Contract #: 04-0120F4Cty: SF/ALA Rte: 80 PM: 13.2/13.9File #: 69.25B**QUALITY ASSURANCE -- NON-CONFORMANCE REPORT****Location:** Changxing Island, Shanghai, P. R. China**Report No:** NCR-000483**Prime Contractor:** American Bridge/Fluor Enterprises, a JV**Date:** 17-Oct-2009**Submitting Contractor:** Zhenhua Port Machinery Company, Ltd (ZPMC), Changxing Island**NCR #:** ZPMC-0456**Type of problem:**

Reference Description: Missed MT Indication by QC on excavated welds prior to welding repair on 1AW/1AAW Side Panel Transverse Splice

Job Name: SAS Superstructure
Document No: 05.03.06-000446

Welding	Concrete	Other	
Welding	Curing	Procedural	Bridge No: 34-0006
Joint fit-up	Coating	Other	Component: 1AW to 1AAW Side Panel Splice Weld OBW1A-004
Procedural	Procedural	Description: Missed MT indication by QC

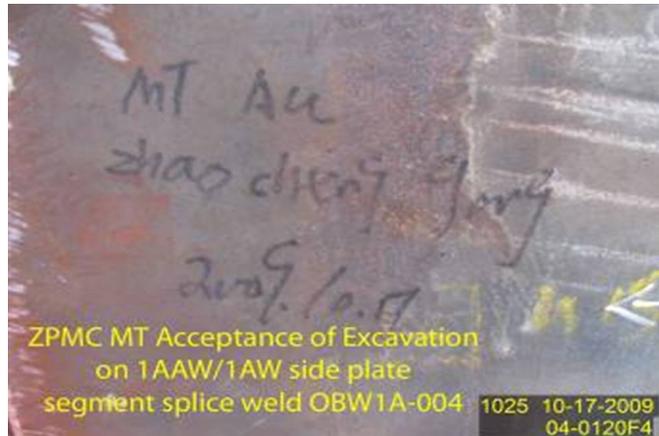
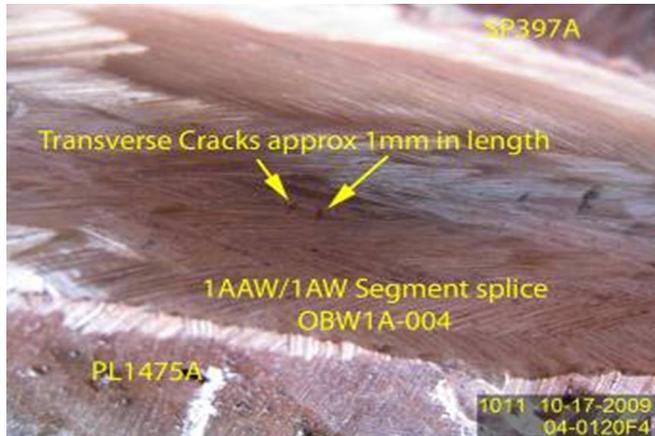
During random visual inspection the QA Inspector performed Magnetic Particle Testing (MT) of an Ultrasonic Testing (UT) reject excavation in the segment CJP Side Plate splice (OBW1A-004), cross beam side joining SP397A (1AW) and PL1475A (1AAW). During this verification the QA Inspector discovered three (3) Transverse Cracks in the excavation. One (1) 2 mm crack was located at Y location 1945mm and two (2) 1mm cracks at Y location 2785mm from the cross beam side Edge Plate.

AWS D1.5-2002 Section 3,7,2,4 Crack in Weld or Base Metal; The extent of the crack shall be ascertained by the use of MT, PT, or other equally positive means; the metal shall be removed for the full length of the crack plus 50mm [2"] beyond the end of each crack and re-welded.

Submit a repair procedure to the engineer for approval.

Bridge No: 34-0006
Component: 1AW to 1BW Weld #OBW1A-007

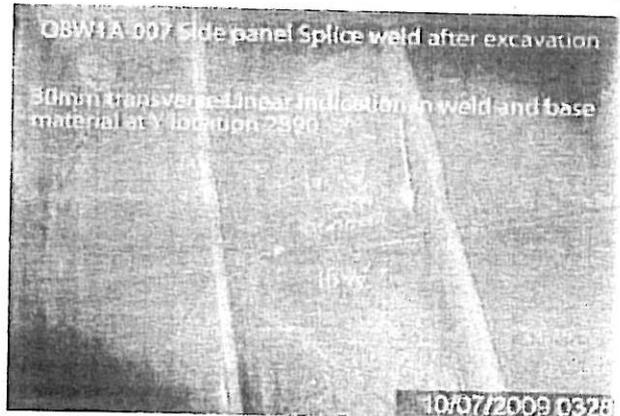
During a random visual observation of ZPMC personnel performing air carbon arc gouging of segment 1AW to 1BW Side Panel transverse splice weld OBW1A-007 at the Counterweight side, the Caltrans Quality Assurance (QA) inspector observed ZPMC was performing this repair utilizing the weld repair report (B-WR8086). This weld repair report did not describe any magnetic particle testing (MT) verifications in the excavation prior to re-welding nor after the completion of welding to ensure that the joint is free of defects. The QA Inspector had the opportunity to perform MT after air carbon arc gouging and observed numerous transverse cracks present ranging from 2 mm to 30 mm in length. No Critical Weld Repair Report was obtained for this weld repair.

The Y locations and the number of Transverse Cracks observed in weld # OBW1A-007:

- 1) Y=50~2475mm, (14) Transverse Cracks
- 2) Y=2720~5030mm, (29) Transverse Cracks

Component: 1AAW to 1AW Deck Panel Weld Splice OBW1-001

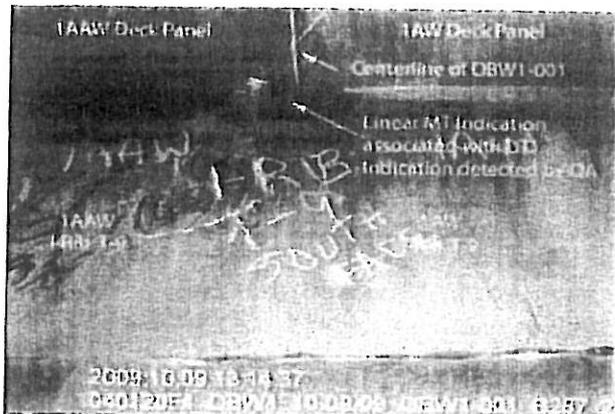
The QA inspector discovered one (1) class "A" rejectable Longitudinal Linear indication in the OBW1-001 (deck panel) weld. This weld was previously tested and accepted by the contractor. This acceptance by the contractor is evident by the presence of the contractor's distinguishing mark indicating QC acceptance. The QA inspector was also able to verify this UT longitudinal indication by magnetic particle (MT) testing from the interior side of the splice weld.

NOTE: The Y location of the Class "A" rejectable Longitudinal Linear Crack is at 5310-5340mm measured from Point W1, or 19750-19780mm if measured from W6. This indication is identified as #25 on ZPMC UT Report B787-UT-8548-1 associated with B-WR7867. The QA inspector verified a 40mm Magnetic Particle (MT) Linear Crack from the interior surface that is associated with Class "A" UT" Rejectable Indication mentioned above.

Submit a repair procedure to the engineer for approval.

Component: 1AW to 1AAW Side Panel Splice Weld OBW1A-00

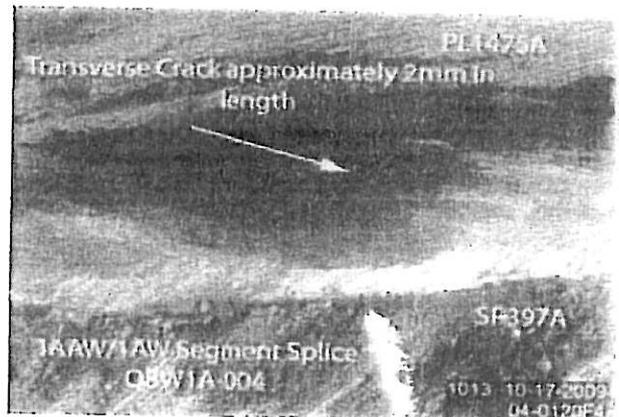
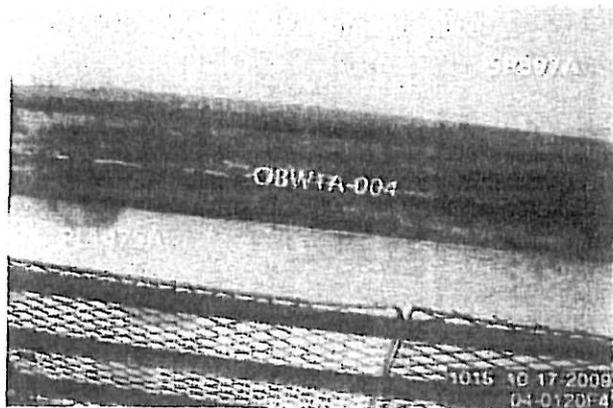
During random visual inspection the QA Inspector performed Magnetic Particle Testing (MT) of an Ultrasonic Testing (UT) reject excavation in the segment CJP Side Plate splice (OBW1A-004), cross beam side joining SP397A (1AW) and PL1475A (1AAW). During this verification the QA Inspector discovered three (3) Transverse Cracks in the excavation. One (1) 2 mm crack was located at Y location 1945mm and two (2) 1mm cracks at Y location 2785mm from the cross beam side Edge Plate.

AWS D1.5-2002 Section 3,7,2,4 Crack in Weld or Base Metal; The extent of the crack shall be ascertained by the use of MT, PT, or other equally positive means; the metal shall be removed for the full length of the crack plus 50mm [2"] beyond the end of each crack and re-welded.

The contractor will repair the weld and perform NDT to verify that the weld is acceptable.

ZPMC has repaired the indications documented in the NCR. ABFJV has conducted the NDT and found that the welds are acceptable.
